**BusConnects Core Bus Corridors  
- Belfield / Blackrock to City  
Centre Core Bus Corridor**

**Stage 1 Road Safety Audit**

Document Ref: P20-138-PSW3-RP-001

### 3.1 Problem

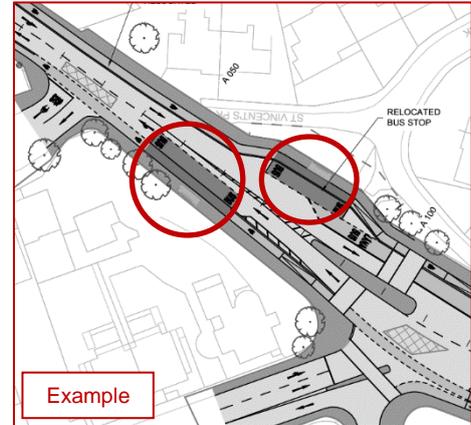
*Summary: Potential for cyclist/pedestrian collisions where cyclists approach the bus stop when passengers are boarding/d disembarking.*

The proposed arrangement for the cycle tracks at a number of the bus stops involves bringing cyclists up to the same level as the footpath, and widening the footpath out to the bus cage, with cyclists occupying the same space where passengers are boarding and disembarking.

Where bus frequencies are moderate to high (as would be expected on a Core Bus Corridor), and/or where cyclist volumes are moderate to high, this could lead to a risk of a cyclist striking a disembarking passenger, who would not expect to have a cyclist approaching alongside the stationary bus.

Review the proposed cycletrack layout at bus stops, in particular the expected volumes of cyclists and buses, and where necessary amend the arrangements to reduce/remove the likelihood of collisions between cyclists and embarking/d disembarking passengers.

3.1	Yes	Yes		
3.2	Yes	Yes		
3.3	Yes	No	Where left-turn vehicles turn with straight ahead cyclists, the vehicles will be controlled with a flashing amber arrow. With respect to the lateral displacement of the cycle track at the junction, the displacement is necessary to accommodate the protection kerb on the corner. In collaboration with the Dublin Cycling Campaign, the approach taper to the junction will be elongated where possible to avoid any sudden left turns by cyclists on the corner, which may give the impression that cyclists are turning left.	Yes

### 3.2 Problem

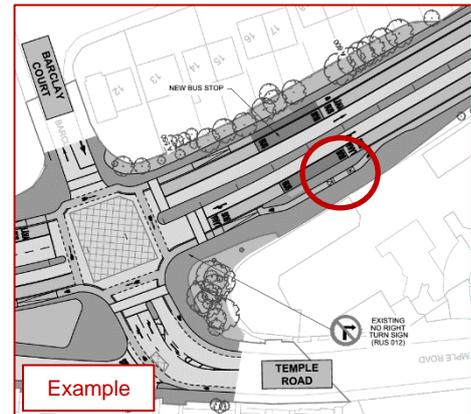
*Summary: Potential for cyclist/pedestrian collisions where bus passengers are required to cross the cycle track when accessing/leaving the floating/island bus stops.*

At some locations a footpath link is indicated between a bus stop and the adjacent footpath, with pedestrians & cyclists occupying the same space for a short distance.

At this early stage in the design process no tactile paving (either warning or guidance) has yet been indicated. Should insufficient guidance be provided at the shared surfaces between island bus stops and the adjacent footpath, this could result in an increased risk of collisions between cyclists and pedestrians where cyclists may be insufficiently aware of the shared area and of the need to moderate their speed, or even come to a halt.

An absence of Guidance Tactile Paving could result in increased difficulties for the visually impaired who may be unaware of how to access or leave the bus stop island.

Guidance Tactile Paving should be provided to guide visually impaired pedestrians to/from the footpath & the bus stop island.

Measures should be provided on the cycle track approaches to these footpath links, for example Ladder & Tramline tactile paving & Yield road markings, so that cyclists are aware that they are approaching a footpath crossing and that they should slow down & yield to pedestrians at these locations.

### 3.3 Problem

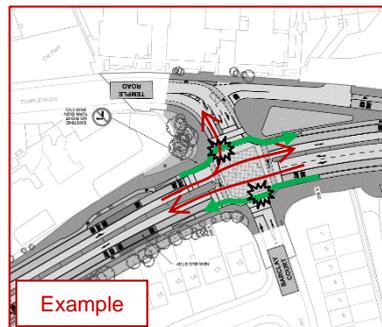
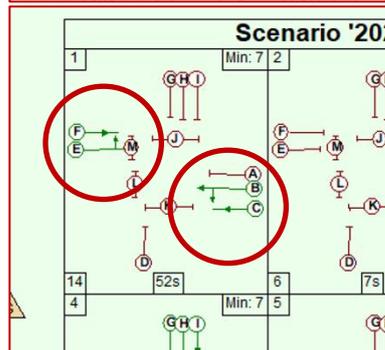
*Summary:* Left turning manoeuvres are indicated during the same signal phase as straight-ahead cyclists where turning drivers may be insufficiently aware of a cyclist proceeding straight at a number of the protected intersections/junctions within the Scheme.

There is a risk that drivers, when given a green signal, may not anticipate a straight-through cyclist to proceed simultaneously. This could arise where a left-turning driver misinterprets the layout as a signalised/toucan crossing on a separate phase, or where a stationary bus at the stop line in the bus lane between the traffic lane and the cycle lane obscures a left-turning driver's view of a cyclist on the cycle lane, and vice versa.

Additionally, left turning drivers may also turn across the path of a bus in the bus lane, leading to side-on collisions.

Reduce the lateral displacement of the straight through cycle lane from the left-turning traffic lane(s) to improve driver's awareness of possible straight through cyclists (e.g. amending the bus lane to also accommodate left-turning traffic on the immediate approach to the signals) and amend the left turn signals so that left turns are on a flashing amber.

This recommendation would also reduce the risk of left turning traffic moving in front of straight-ahead buses.

### 3.4 Problem

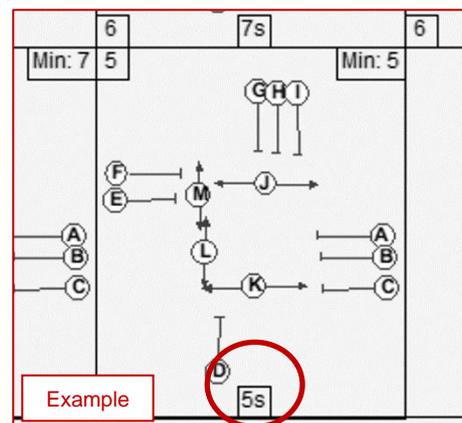
*Summary:* The timing proposed for pedestrian phases at a number of signalised junctions within the Scheme may not be sufficient to allow pedestrians, and in particular the mobility impaired, to complete a crossing safely.

At a number of signalised junctions within the Scheme, pedestrian phases have been indicated as being quite short (e.g. 5 seconds long). The Audit Team are concerned that this will not be sufficient time for non-motorised road-users, in particular the elderly & mobility impaired, to complete a crossing safely.

This could lead to pedestrians remaining within the carriageway when a subsequent green vehicular phase has been triggered increasing the risk of vehicle-pedestrian collisions.

Ensure pedestrian green phases are of a sufficient length such that all non-motorised road users can complete the crossing safely.

3.4	No	No	The 5 seconds indicated represents the time that the solid green man is lit ('invitation to walk'), but there will be additional time whereby the flashing green man will be active, the duration of which is calculated based on the crossing distance.	Yes

*Location:* BCIDC-ARP-GEO\_GA-1415\_XX\_01-DR-CR-0005 (Rev L01) and BCIDC-ARP-GEO\_GA-1415\_XX\_01-DR-CR-0007 (Rev L01)

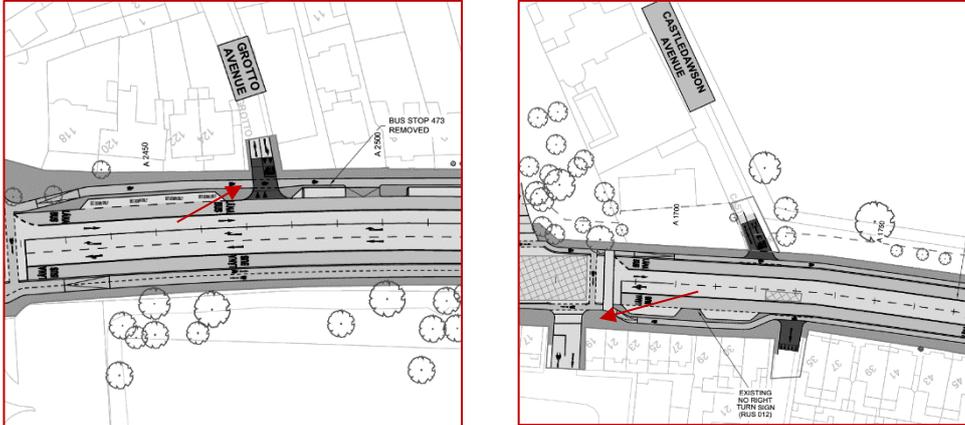
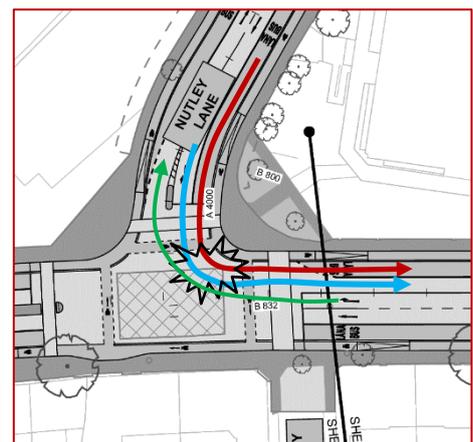
*Summary:* Visibility (to cyclists/pedestrians) for drivers turning left into a side road may be impeded by vehicles parked in the parallel parking bays, leading to vehicle/pedestrian and vehicle/cyclist collisions.

Vehicles occupying parking areas or set-down areas may block visibility towards cyclists and pedestrians on the footway, resulting in possible vehicle/pedestrian and vehicle/cyclist collisions when traffic turns left into the respective side road.

Ensure sufficient inter-visibility between drivers and pedestrians/cyclists is provided at these locations.

3.5	Yes	Yes		
3.6	Yes	Yes		
3.7	Yes	Yes		
3.8	Yes	Yes		
3.9	Yes	Yes		
3.10	Yes	Yes		
3.11	Yes	Yes		
3.12	No	No	The proposed solution here is to provide bus priority signals	Yes

*Location:* BCIDC-ARP-GEO\_GA-1415\_XX\_01-DR-CR-0012 (Rev L01)

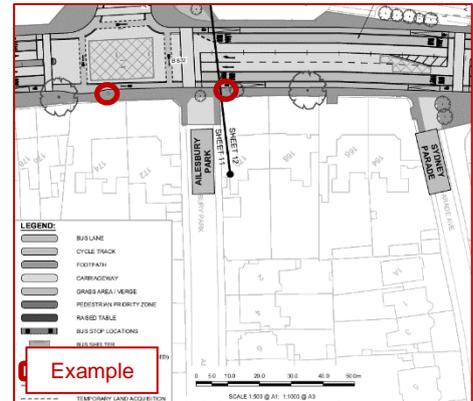
*Summary:* It is unclear if there will be sufficient space within the Nutley Lane/Merrion Road signalised junction to accommodate the swept path of HGVs and buses, particularly where adjacent turning lanes receive a green signal during the same phase.

Information regarding the swept path of vehicles undertaking turning movements at proposed signalised junctions within the Scheme have not been provided to the Audit Team. The Audit Team are concerned that there will not be sufficient space at all junctions to accommodate the swept path of all vehicles, particularly HGVs and buses, within the proposed junction layouts. This is a particular concern where adjacent turning lanes proceed simultaneously on one phase as drivers may encroach within the path of an adjacent vehicle resulting in low-speed side-swipe collisions.

Additionally, this problem may be exacerbated where left turners from Nutley Lane proceed within the same phase as right turners from Merrion Road.

A comprehensive swept path analysis should be undertaken to demonstrate that all new, and revised, signalised junctions can sufficiently accommodate the swept path of all vehicles. Where constraints are identified, the layout should be revised to ensure all vehicle movements can be accommodated.

### 3.7 Problem

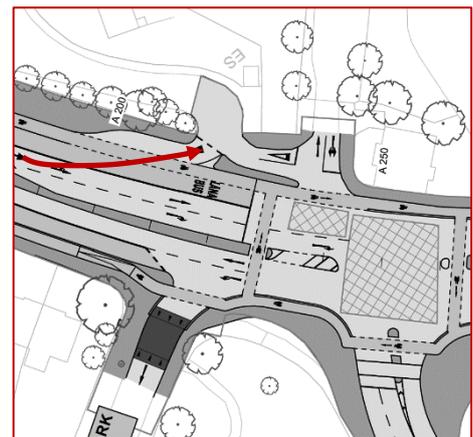
*Summary: Heritage features indicated within the footpath and cycle track may present obstacles to pedestrians and cyclists.*

A number of Heritage Features within the footpath and cycle track have been indicated as being retained throughout the project. It is unclear from the drawings provided what these features are and whether they will result in significant obstacles to pedestrians and cyclists.

Large features within the footpath and cycle track may also reduce the effective width of the footpath and cycle track which may lead to VRUs having to step into the cycle track, from the footpath, or adjacent carriageway to allow oncoming VRUs to pass resulting in an increased risk of being struck by a vehicle or cyclist.

Ensure the retained Heritage Features do not present obstacles to pedestrians and cyclists.

*Location: BCIDC-ARP-GEO\_GA-1415\_XX\_01-DR-CR-0001 (Rev L01)*

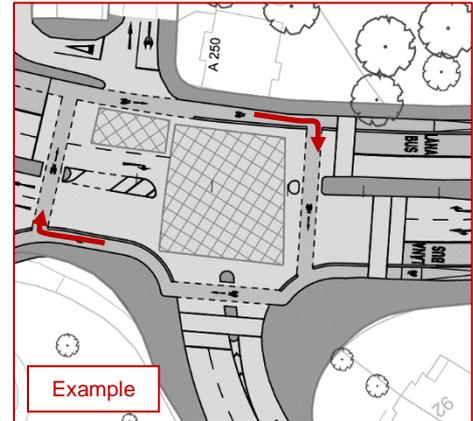
*Summary: Limited visibility to cyclists may lead to side-on and side-swipe collisions.*

Westbound vehicles wishing to access St Vincent’s Park must cross a Bus Lane and a cycle lane to access the left lane diverge/yield. The angle of approach may be such that visibility is limited for left turners, leading to side-swipe and side-on collisions with cyclists.

This problem may be exacerbated by a sense of urgency where drivers attempt to turn left ahead of a following bus, which may lead to a driver being less focussed on a cyclist.

Left turning traffic should merge with the bus lane upstream of the side road access.

Alternatively, the left turn diverge should be removed, with left turns being incorporated within the signalised junction. This approach may also simplify pedestrian movement through the junction, which is currently unclear.

### 3.9 Problem

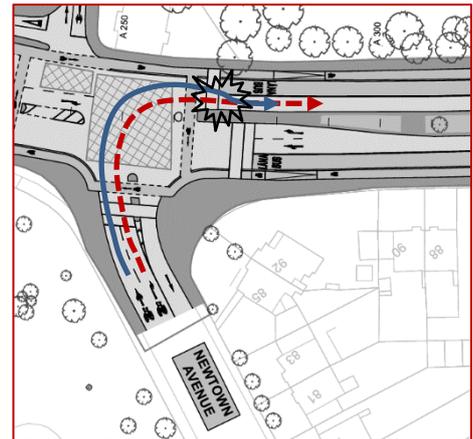
*Summary: Right turning cyclists may impede straight-ahead cyclist movement, leading to rear-end-shunt and side-swipe collisions.*

Cyclists waiting to turn right at signalised junctions will likely wait within the cycle track until they are given a green signal. However, the space within the cycle track is limited, so waiting cyclists may impede straight-ahead cycle movement, increasing the risk of rear-end-shunt collisions with following cyclists, or force cyclists to enter the footway or carriageway to continue around the stationary cyclists, leading to cyclist/pedestrian collisions, or side-swipe collisions with buses.

Stationary cyclists should be provided with space to wait, which is outside the path of straight-ahead cyclists.

*Location: BCIDC-ARP-GEO\_GA-1415\_XX\_01-DR-CR-0001  
(Rev L01)*

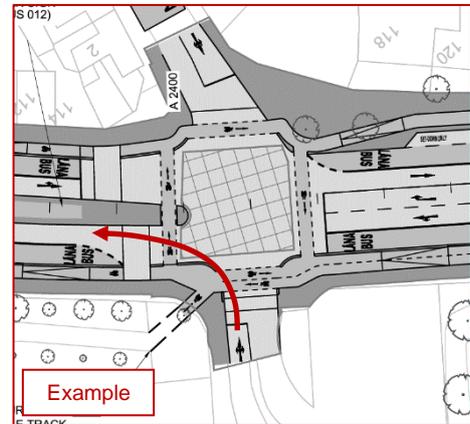
*Summary: Two right turn lanes in Newtown Avenue do not correspond with one single lane on Temple Hill and may lead to side-swipe collisions as drivers quickly attempt to exit the bus lane.*

Newtown Avenue is indicated as having two lanes ('left/straight/right' in the nearside lane and 'right only' in the offside lane). Temple Hill's westbound carriageway has a bus lane and a straight-ahead lane, so cannot accept two right turning vehicles. This may lead to right turning vehicles in the nearside lane having to suddenly merge with traffic in the offside lane when they observe the bus lane, leading to side-swipe collisions.

Additionally, it is unclear if two right turning vehicles can navigate the right turn manoeuvre at the same time. Insufficient width may lead to side-swipe collisions before entering Temple Hill.

The nearside traffic lane on Newtown Avenue should be left and straight-ahead only.

*Example: BCIDC-ARP-GEO\_GA-1415\_XX\_01-DR-CR-0007 (Rev L01)*

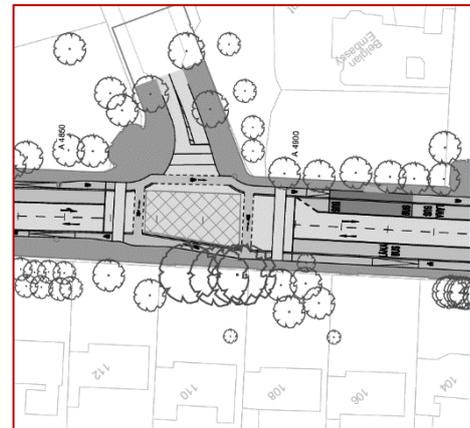
*Summary: It is unclear if there will be sufficient space within the signalised junction to accommodate the swept path of all vehicles.*

Information regarding the swept path of vehicles undertaking turning movements at proposed signalised junctions within the Scheme have not been provided to the Audit Team. The Audit Team are concerned that there will not be sufficient space at all junctions to accommodate the swept path of all vehicles, particularly HGVs and buses, within the proposed junction layouts. This is a particular concern where protected cycle lane infrastructure reduces the turning radii further.

A comprehensive swept path analysis should be undertaken to demonstrate that all new, and revised, signalised junctions can sufficiently accommodate the swept path of all vehicles. Where constraints are identified, the layout should be revised to ensure all vehicle movements can be accommodated.

*Location: BCIDC-ARP-GEO\_GA-1415\_XX\_01-DR-CR-0014 (Rev L01) and BCIDC-ARP-GEO\_GA-1415\_XX\_01-DR-CR-0020 (Rev L01)*

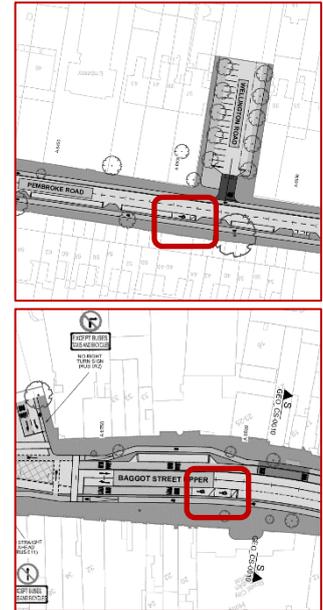
*Summary: Road narrowing may lead to side-swipe collisions.*

Road users travelling east on Merrion Road may be unaware of the road narrowing at Shrewsbury Road, which will require buses to merge with general traffic. The relatively short merge length through the junction may lead to unsafe merging and side-swipe collisions, particularly during a green signal phase.

A similar concern exists at the junction of Baggot Street Lower and Herbert Place.

Provide appropriate signage to warn drivers of the road narrowing in good advance of the signalised junction.

*Location:* BCIDC-ARP-GEO\_GA-1415\_XX\_01-DR-CR-0018 (Rev L01) and BCIDC-ARP-GEO\_GA-1415\_XX\_01-DR-CR-0019 (Rev L01)

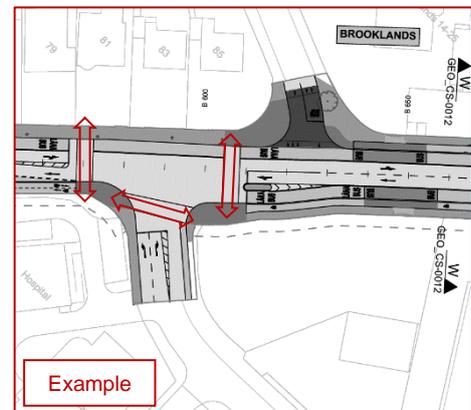
*Summary:* Insufficient width of mobility parking space may increase the risk of mobility users conflicting with moving traffic, leading to serious personal injury.

Parking space dimensions have not been provided to the RSA Team at this early stage in the design process, so the width of parking spaces is unknown. However, the mobility parking spaces on Pembroke Road and Baggot Street appear to share the same width as adjacent parking spaces, despite needing additional width to accommodate users getting in and out of their vehicles. Insufficient width for mobility users may increase the risk of personal injury should a user be struck by a moving vehicle when accessing/exiting their vehicle.

Ensure the width of mobility parking spaces is compliant with the Traffic Signs Manual.

Additionally, ensure dropped kerbs and tactile paving is provided at each mobility parking space to support access between the parking space and the footway.

To Be Completed by Designer				To Be Completed by Audit Team Leader
Paragraph No. in Safety Audit Report	Problem Accepted (Yes/No)	Recommended Measure(s) Accepted (Yes/No)	Describe Alternative Measure(s). Give reasons for not accepting recommended measure	Alternative Measures or Reasons Accepted by Auditors (Yes/No)
			whereby the inbound general traffic lane and the bus lane are controlled by separate phases and will not be permitted to pass through the junction simultaneously.	
3.13	Yes	Yes		
3.14	Yes	Yes		
3.15	No	No	The stage includes the inbound bus phase active while the Anglesea Road ped phase is also active. There are no left turning buses so there is no conflict. Notwithstanding the above, the proposed staging arrangement of this junction has been amended and this pedestrian phase is no longer proposed to be active at the same time as the bus or cycle phase.	Yes
3.16	Yes	Yes

*Location: BCIDC-ARP-GEO\_GA-1415\_XX\_01-DR-CR-0022 (Rev L05)*

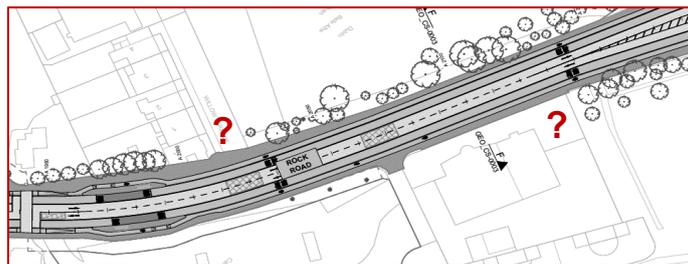
*Summary: Lack of pedestrian facilities on Greenfield Park may lead to vehicle/pedestrian collisions.*

The provision of a high-quality bus corridor on Nutley Lane may increase the number of local residents choosing public transport when commuting to work, school or college. This growth will likely place increased demand on the existing pedestrian facilities on, or near, the new bus corridor. This may include residents from Stillorgan Road and Greenfield Park. However, there is currently no signalised pedestrian crossing on Greenfield Park. Pedestrians, particularly visually and mobility impaired pedestrians, traveling on Stillorgan Road (western side) and Greenfield Park (southern side) may find it difficult to navigate the crossings on route to the improved bus facilities, increasing the risk of vehicle/pedestrian collisions.

A signalised pedestrian crossing on Greenfield Park should be incorporated into signalised junction, including dropped kerb and tactile paving.

Should this be outside the scope of this project, the Designer shall bring this to the attention of the Local Area Engineer for review and consideration.

- 4.4 The existing cross section on the eastbound Rock Road carriageway includes a pedestrian footway, parallel parking, a nearside traffic lane (that includes an advisory cycle lane within it) and an offside traffic lane.

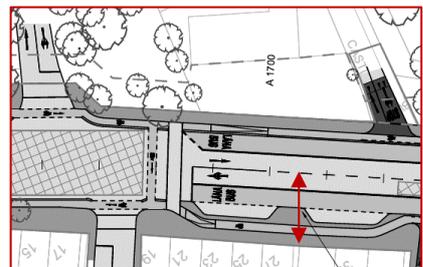
The proposed layout indicates a cross section that includes a pedestrian footway, an off-road cycle track, a buffer zone, parallel parking, a nearside bus lane and an offside traffic lane.

In the absence of dimensions, it is unclear to the RSA Team if the proposed layout can fit within the existing footprint. Ensure the proposed cross section can be accommodated within the available footprint.
